Reference: Case No. PD-270-RBN, The Avenue at Denton Tap, a zoning change request from Commercial to a Planned Development to allow 29 multifamily units and 8,575 square feet of office/retail uses on 1.77 acres of property located at the northwest corner of Southwestern Boulevard and South Denton Tap Road.

STAFF REPORT

CASE NO. PD-270-RBN, The Avenue at Denton Tap

Site Plan

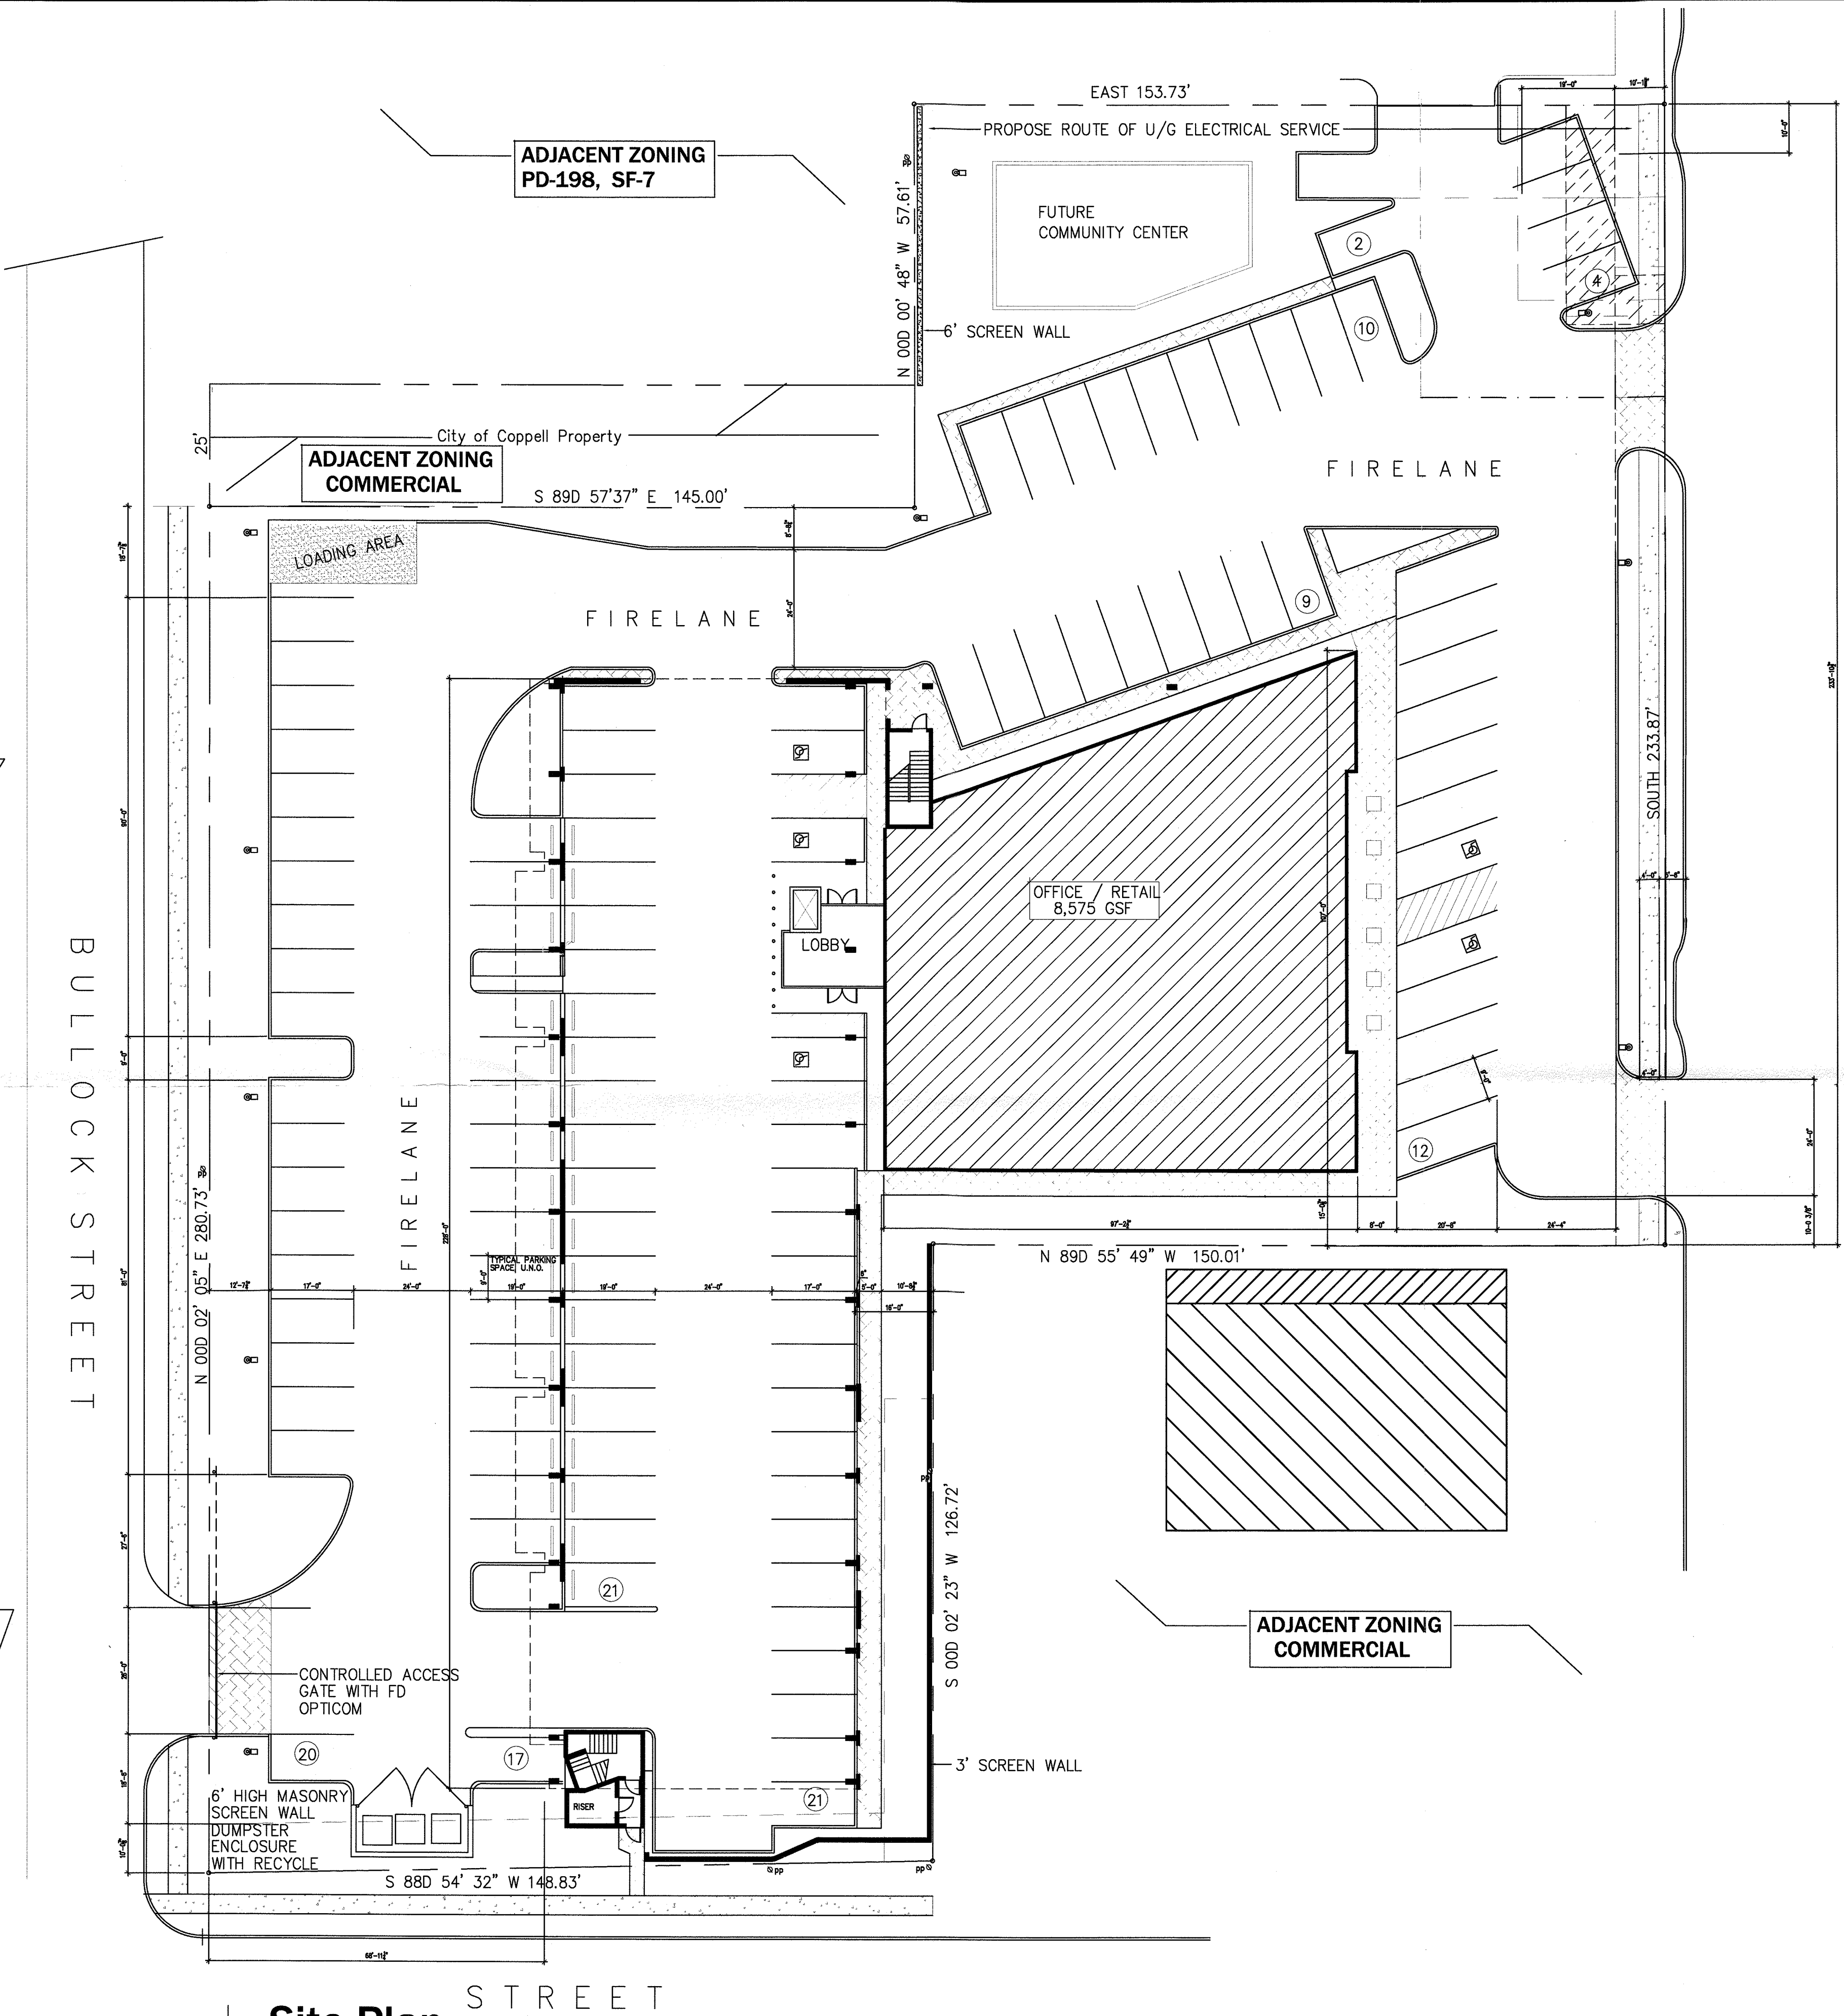
This building is proposed to be setback 63 feet from Denton Tap Road and 69 feet from Bullock Street. It is recommended that the 69-foot setback be supported to keep a buffer and transition from the residential neighborhood into the proposed higher intensity mixed use development.

A 36-foot setback is proposed along the northwest property line, which is adjacent to a 25-foot right-of-way providing a greater separation from the residential neighborhood. The main building is 63 feet from the Denton Tap Road right-of-way where the RBN District calls for a building to be no more than 15 feet from the lot line. Staff can support this deviation, as both a drive and parking are warranted for the office/retail use.

This proposal exceeds the 116 parking space requirement by providing 119 spaces. Both the *Comprehensive Plan* and the RBN District encourages structured (garage) parking. In this development 41 of the 119 spaces are contained within the structure. It is recommended that this parking area on the first floor be better screened with a three-foot masonry wall incorporated into each façade and this has

been listed as a condition of approval. Beyond the structured parking are 41 spaces in a parking lot. This area is proposed to be screened with a 12 foot wide landscaped area east of Bullock Street. The proposed off-street parking and drive (similar to a slip street recognized in the Comprehensive Plan). The proposed parking located on the Denton Tap Road side is angled with a one-way drive to provide an opportunity for streetscaping without actually having dangerous on-street parking on Denton Tap.

1 LANDSCAPE PLAN
SCALE 1"=20'

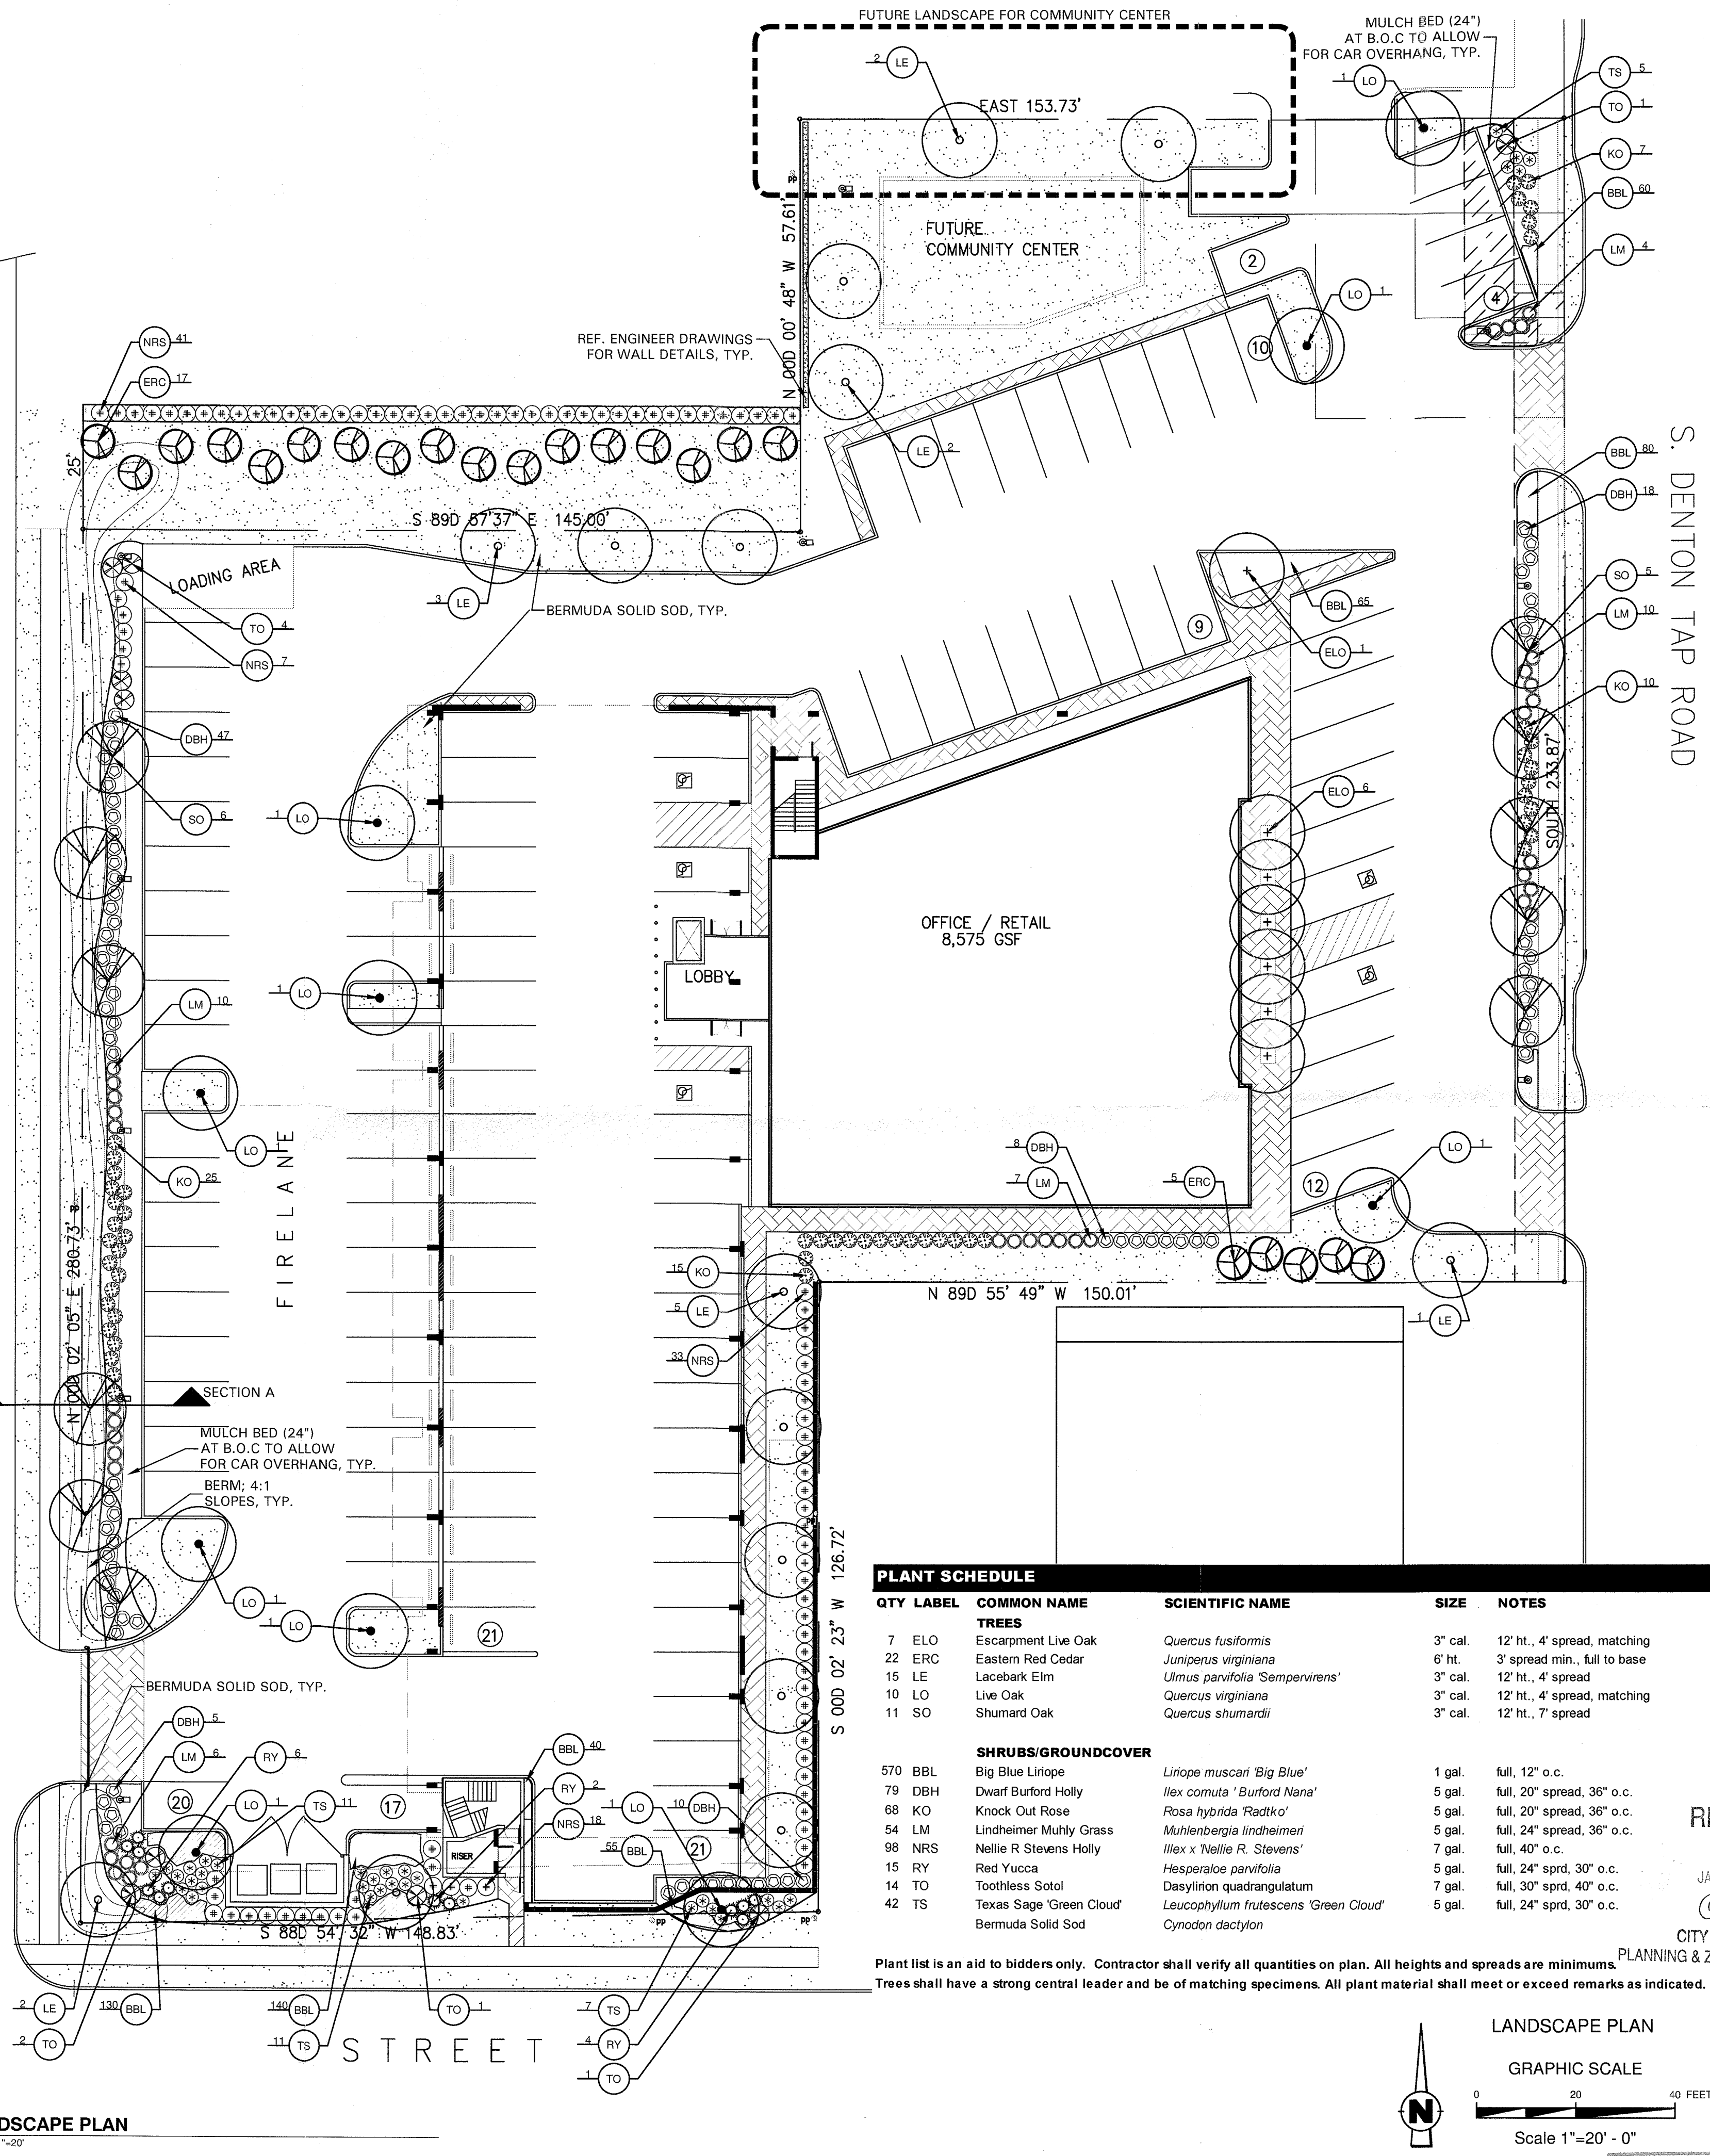
The landscape areas within a RBN District are different than the typical business zoning districts where under the RBN, a minimum 15% open space/common area is required. The proposal indicates that 17% has been provided. The streetscaping of the retail/office area is adequate where street trees are being provided. However, additional landscape islands are being recommended in the parking lot where there is no structure over the parking. Not more than 15 parking spaces are typically permitted without an island and one island is required at the end of each parking row; therefore, three islands are recommended. Also, the applicant has agreed to add an evergreen area of landscaping (containing Nellie R. Stevens and Eastern Red Cedars) to the 25 foot right-of-way strip located northwest of the property to better buffer/screen this proposal from the existing residential neighborhood.
